SUMMARY OF SILICON ANOMALIES

The following table provides a summary of ADSP-BF561 anomalies and the applicable silicon revision(s) for each anomaly.

107. 05000471 - Boot Failure When SDRAM Control Signals Toggle Coming Out Of Reset:**DESCRIPTION:**

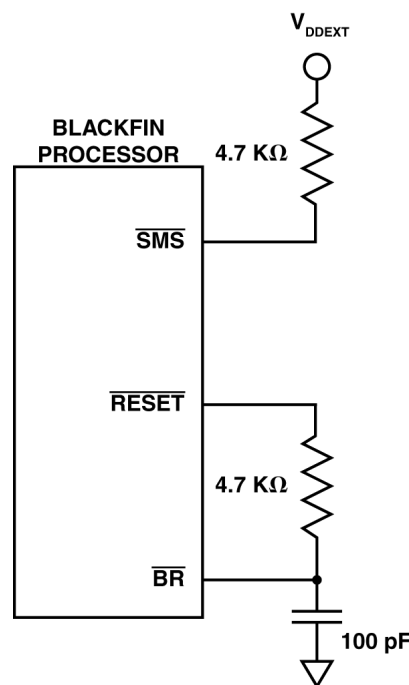
When $\overline{\text{RESET}}$ is de-asserted at the conclusion of the power-on reset sequence (not applicable to warm resets), there is a very small chance that the SDRAM control signals ($\overline{\text{SRAS}}$, $\overline{\text{SCAS}}$, $\overline{\text{SWE}}$, $\overline{\text{SMS}}$, $\overline{\text{SCKE}}$, and $\overline{\text{SA10}}$) may be driven low for a single CLKOUT cycle. This activity can cause certain SDRAM devices to enter engineering test modes that result in the SDRAM driving data onto the shared EBIU data lines that the Blackfin processor is going to read from when configured to boot or execute from parallel flash.

When booting from parallel flash (BMODE = b#01), this contention corrupts the boot stream and causes the processor to hang. At this point, power-cycling the processor is required to clear the condition.

When executing from parallel flash (BMODE = b#00), this contention corrupts the op-codes and causes the processor to execute incorrect or illegal instructions, which may result in improper application execution or unexpected exceptions.

The delayed version of $\overline{\text{RESET}}$ seen on $\overline{\text{BR}}$ causes the Blackfin processor to continue to three-state the SDRAM control signals after the rising edge of $\overline{\text{RESET}}$ for longer than one CLKOUT cycle, which over-rides the glitch behavior described by this anomaly. The pull-up resistor on the $\overline{\text{SMS}}$ pin ensures that the memory-select signal remains de-asserted while the processor is three-stating the $\overline{\text{SMS}}$ output. Additional pull-ups are needed on the $\overline{\text{AMSx}}$ signals as well. This drawing contains the local connections to the Blackfin processor only. The $\overline{\text{RESET}}$ input pin is connected to the reset supervisor circuit, and the $\overline{\text{SMS}}$ output pin connects to the SDRAM memory select pin.
